Our ref: KT/2016/121628/03-L01
Your ref: TR010006
Date: 28 April 2017

**APPLICATION FOR A DEVELOPMENT CONSENT ORDER FOR
CONSTRUCTION OF THE PROPOSED M20 JUNCTION 10A, ASHFORD, KENT**

M&F Technical Note

Project Name	M20 Junction FRA Hydraulic Modelling
Date	28/04/17
Prepared By	Anthony Hammond – M&F
Prepared For	Ghada Mitri – P&SO

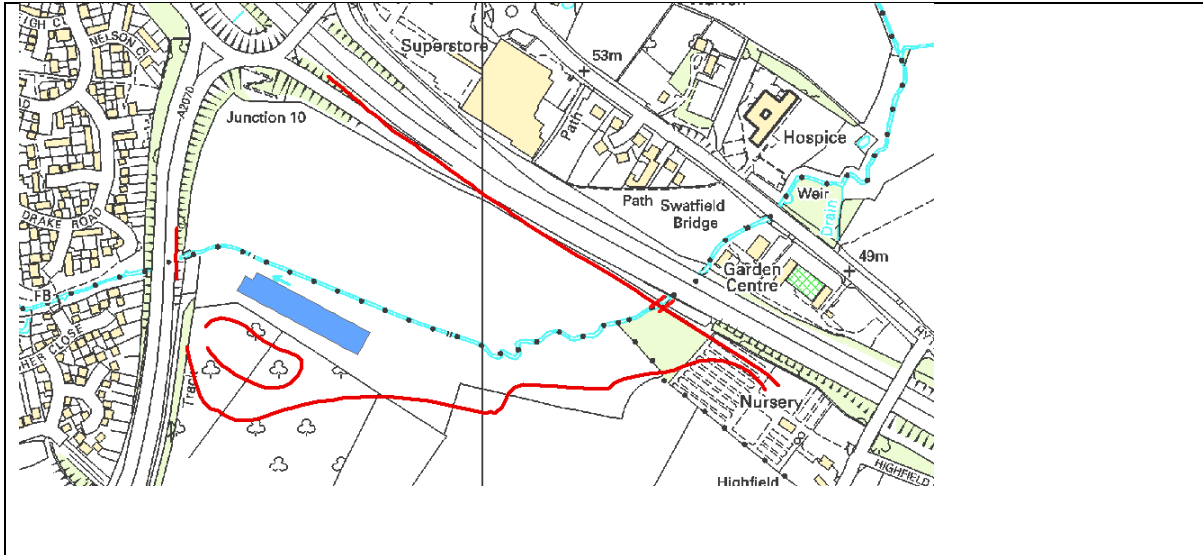
The below map shows the proposed embankments (red) and a flood storage area (blue).

It is important that the alterations satisfactorily represent the proposed developments. At this stage the details of proposals are not specific. The modelled road embankments are not quite the same as the road embankments in figure 4 (outline development plan) in the initial FRA (ref:08-125R_006 – FRA – Sevington West – rev A). The reviewer has seen no documentation outlining design drawings of the mammal ledge or the embankment bridge. The bridge spans the river wide enough so that the largest flow modelled does not reach the soffit and the details of which are therefore not impacting model results. A representation of the mammal ledge has not been attempted and instead a constriction of the associated culvert has been applied to represent the possible hydraulic losses. At this stage, with no further information, this is necessarily sufficient, however it is strongly recommended that once specific details are outlined, they are compared to the modelled representation to ensure the hydraulic impacts are consistent.

1. Any further details of proposed development should be cross referenced with the schematisation in the model. If it is considered that there is significant difference, this impact assessment should be revisited.
2. The 105% scenario should be re-run with panel markers along the Aylesford stream. This may improve the stability issues and provide more confidence in the results downstream.
3. The differences in depths in the flood plain have not been investigated here and flood depth difference maps for all scenarios should be provided.

Figure 3.1 (1%AEP)

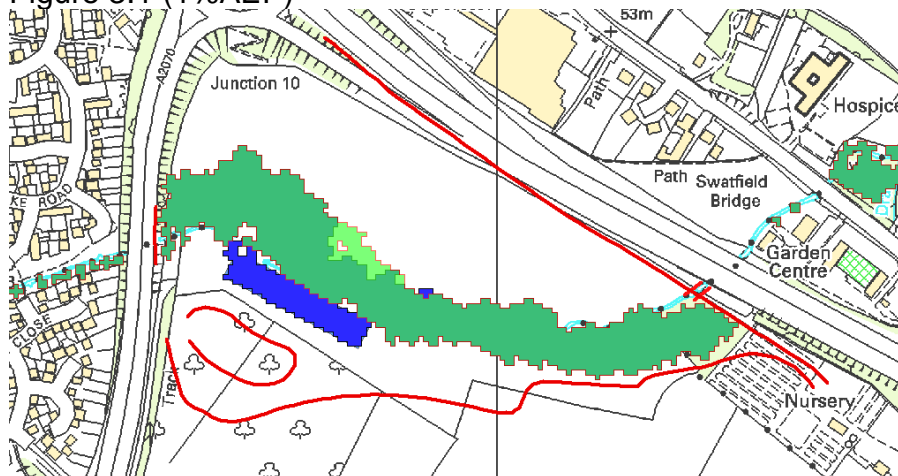
The results before and after development are very similar with in-channel reductions in water levels for the most part. The only reductions close to significant are at cross sections in and around the proposed mammal ledge (represented by the culvert constriction). This reduction is due to the increase in velocity through the culvert, which has the impact of reducing head in the immediate vicinity. The flood extents are almost identical for pre and post development scenarios except for the vicinity of the proposed flood storage area. This has the effect of reducing extents on the other side of the river. The light green area is reduced due to the storage area (blue) in figure 3.1.

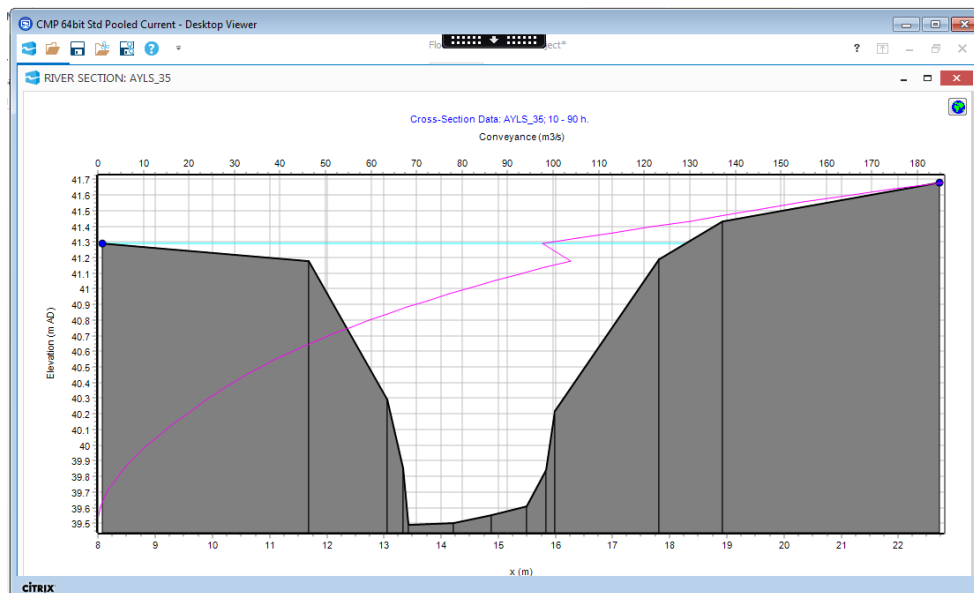
populate for EA consideration and a few key aspects of review were checked. Hydrographs and bitmap outputs from flood modeller pro were checked for stability issues and conveyance was checked for possible causes of instability. For the most part stability issues do not appear to significantly impact the hydrographs along the Aylesford stream. However, the 105% scenario shows significant oscillations in cross sections downstream of the proposed development (starting at the area circled in red)

It is noted that conveyance immediately upstream of the hydrograph oscillations, at cross section AYLS_35, is not monotonic (figure 3.2) as can be seen by the pink line with a kink. Conveyance is mentioned in the review template by MMSJV. It is unknown whether or not an attempt was made to improve the conveyance.

Figure 3.3

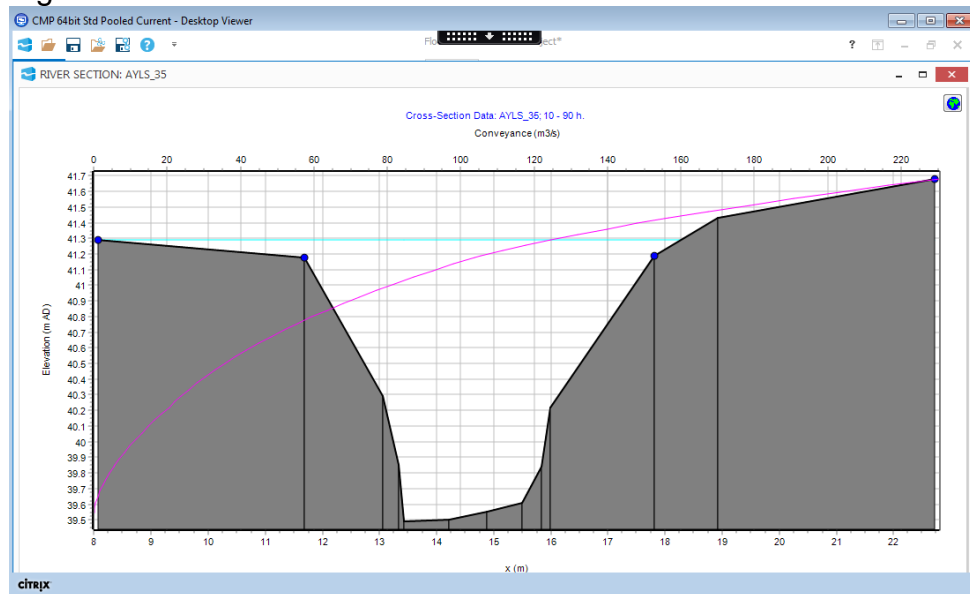
An addition of panel markers (blue dots) as in figure 3.3 below, demonstrates that this is easily rectified and should have beneficial effects on the stability. The flow equations, of which conveyance is one of many terms, are assisted by breaking the cross section up into discrete sections with panel markers. It is specifically an issue when flow comes out of bank. In both figure 3.2 and 3.3 the maximum flow level is shown by a turquoise line and can be seen to come out of bank at the point of conveyance reducing as levels increase (which shouldn't happen).

This simple addition of panel markers may solve the instability issue. Despite the oscillations, results can be obtained and appear the same for pre and post development, as with all the other scenarios. Given this fact and the fact that the levels upstream where stability isn't causing oscillation in water level, it is considered unlikely that the difference in results would be significant (once rectified). However, it is recommended that the model is re-run for the 105% event with the addition of panel markers for cross sections along the Aylesford stream. If this is not undertaken there is less confidence that the true impact of the proposal on the 1%AEP+105% scenario is represented.
